RESOLUTION NO. 16-220

Subject: **Approve use of Unforeseen Conditions Allowance and Contingency Allowance for construction of Phase IA of the Truman Waterfront Park**

PROJECT: Truman Waterfront Park Phase IA

FIELD CHANGE DIRECTIVE
No. 03

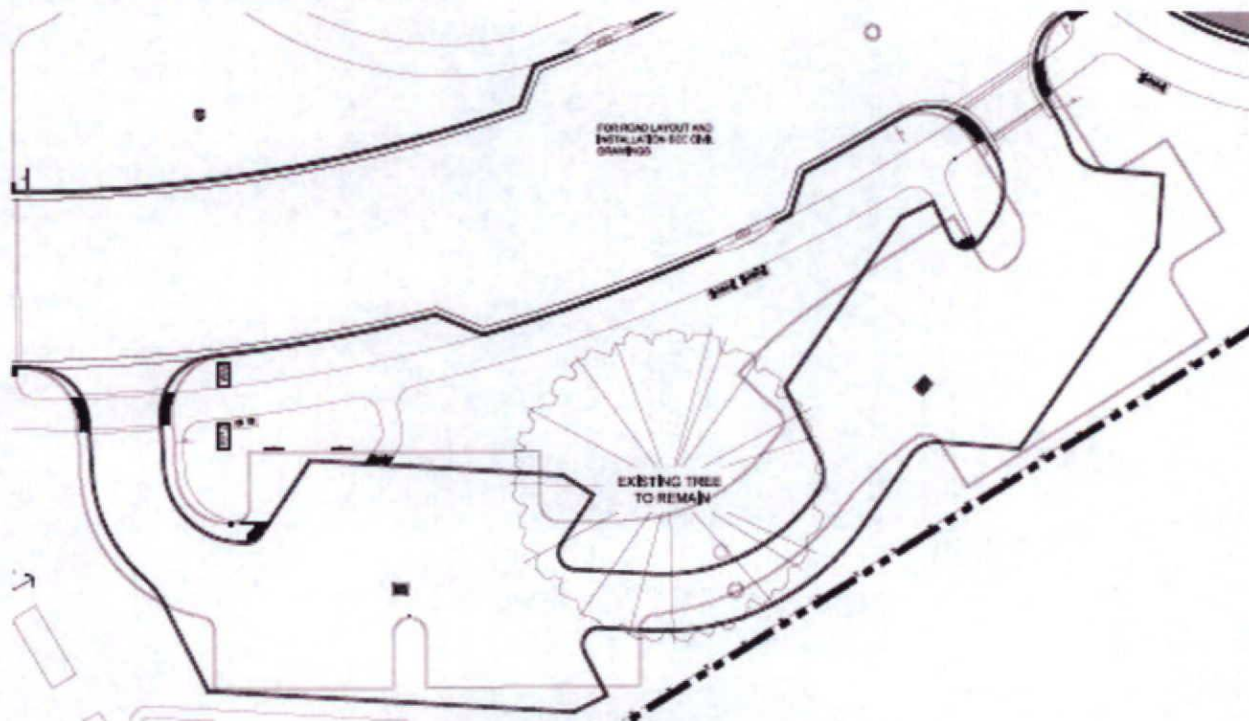
The Delta 3 drawing revisions generally consist of reconfiguring the parking near the existing Seagrape tree (described as Tree No. 38 on LT-05 and LT-06) along the east side of the property from square spaces with two-way traffic (the lighter edge of pavement below) to angled spaces with one-way traffic (the darker edge of pavement lines below). The diagram below shows the general shift of the road alignment from the bidding documents, shown in light gray lines to the current design, shown with black lines:

This change consists of a parking lot reconfiguration and lies to the east of and is adjacent to the section of the southerly spine road between stations 21+00 and 24+00. This change also incorporates a modification of the exfiltration trench system near Ficus #41 located to the Southwest of the Southard Street roundabout at the main entrance to the park. While every effort has been made to create a summary of all of the changes made during this revision, the contractor shall examine the plans and note any additional changes.

1. New alignment of access road that provides the baseline for reconfigured parking stalls.
2. Locations of modified entrance/exit to the said access road for reconfigured parking lot.

3. Said access road was modified to be a one-way road with 60-degree parking stalls as opposed to the previous design of a two-way road with 90-degree parking stalls.

8. Retention Area E was reconfigured to accommodate changes to said parking lot. See Sheet CP-05.
9. Pavement markings in the previously described area have been moved to align with the modified roadway and should be examined by referencing sheets CM-03 & CM-05.

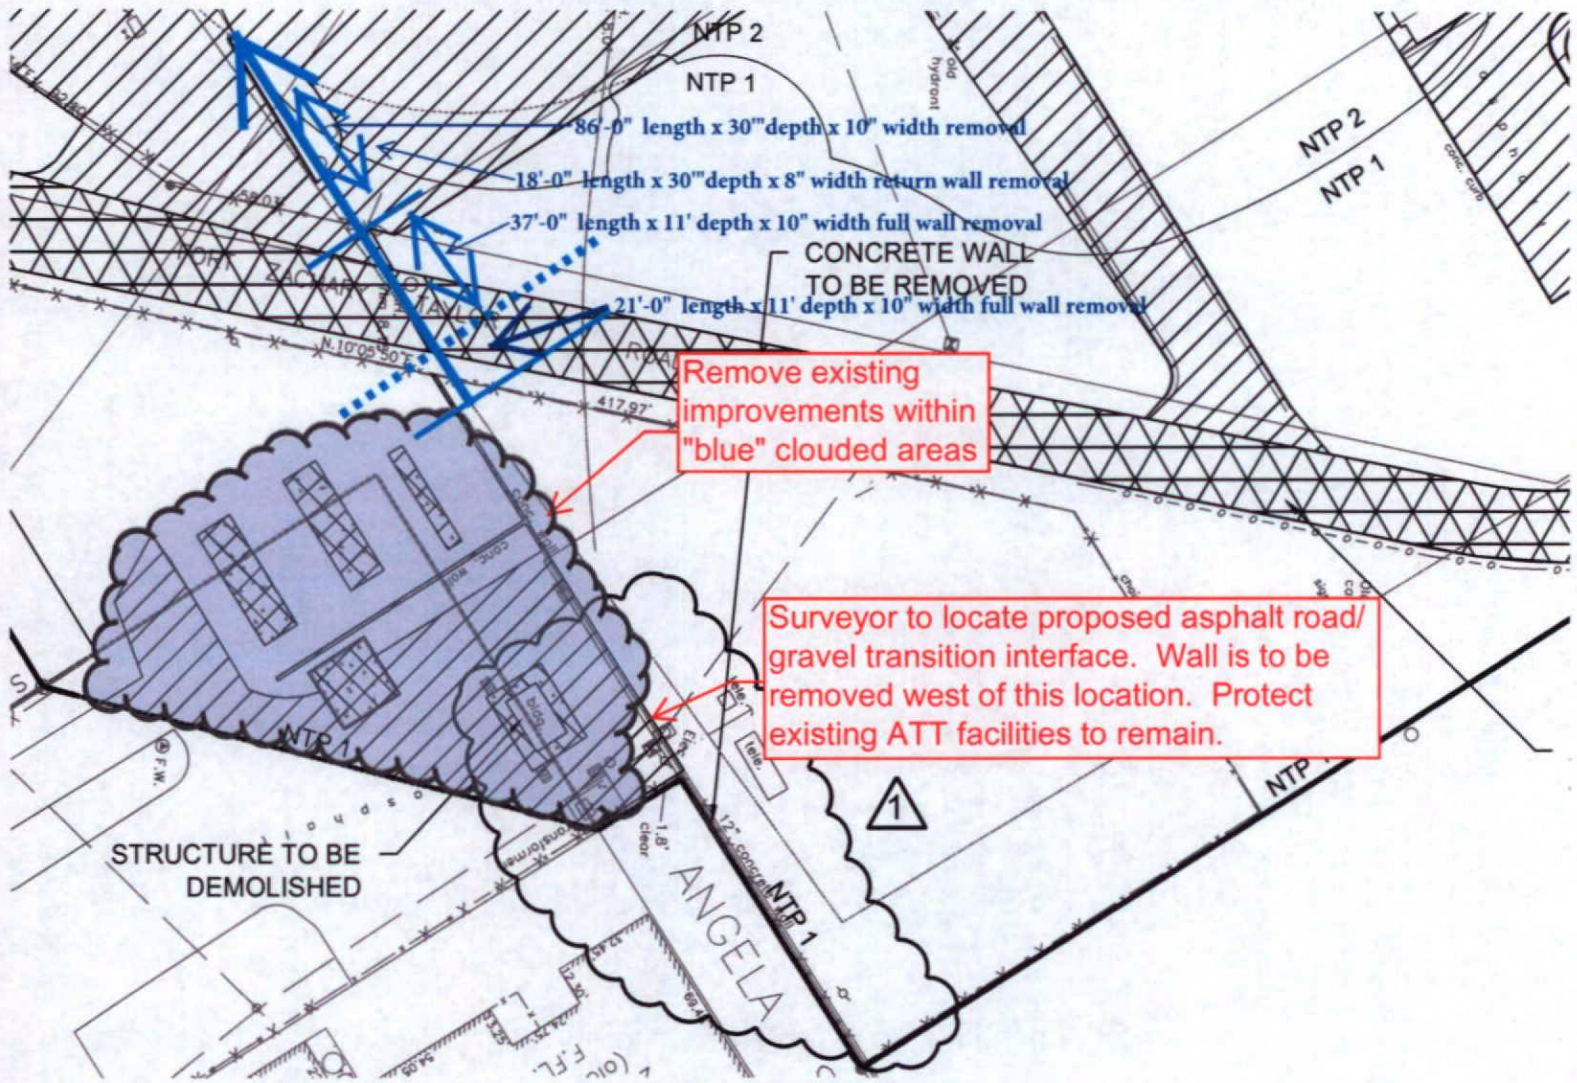
Demo of the concrete retaining wall from 14'-0" from property line per RFI 023 revealed the concrete wall was 6'-9" below grade, greater than 4'-5' typical for retaining wall condition. The wall continued beyond location where wall visibly terminated to into the ground: 21' length x 11' depth x 10" [not included in this CO].

Additional demo requested for Unforseen Seawall Condition:

86' length x 2'-6" depth x 10" partial wall removal only

18' length x 2' -6" depth x 8" partial wall removal only

37' length x 10' depth x 10" width full wall removal

SK-003 - Coordination - Subgrade Work Plan

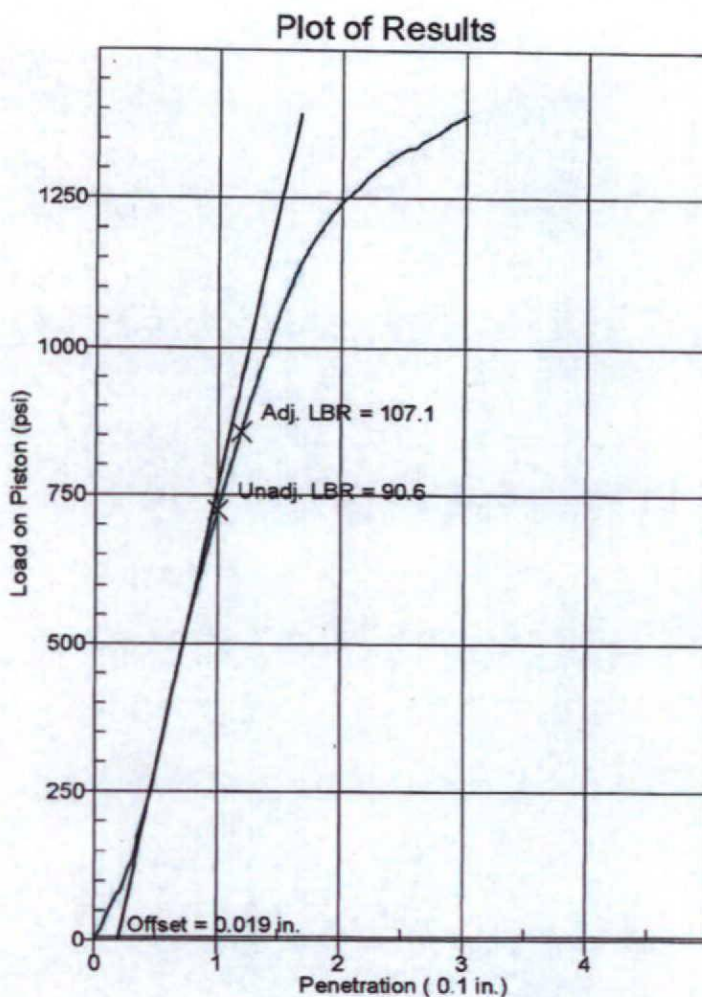
During the visit and Subgrade discussion last Monday, 23 May 2016, we agreed to proceed with LBR testing of the "Superblend" material. The result = unadjusted 90.6, please see the attached.

It was the professional opinion of the Soils Testing technicians with Concrete Analysis & Testing Laboratories, Inc. that the existing materials from the Fort Zachary entrance area to SSMH 1 were not suitable to achieve LBR40 through mixing based on previous site sampling and testing data results. To mix with the existing materials on site would risk inconsistent results and potential settling over time.

This proposal is for the removal / replacement of the 12" subbase with a suitable material as referred to in our discussions and per the Nutting Report, page 9, paragraph, Paving Areas. The attached sketch illustrates the quantity of materials and specific area of impact at this time.
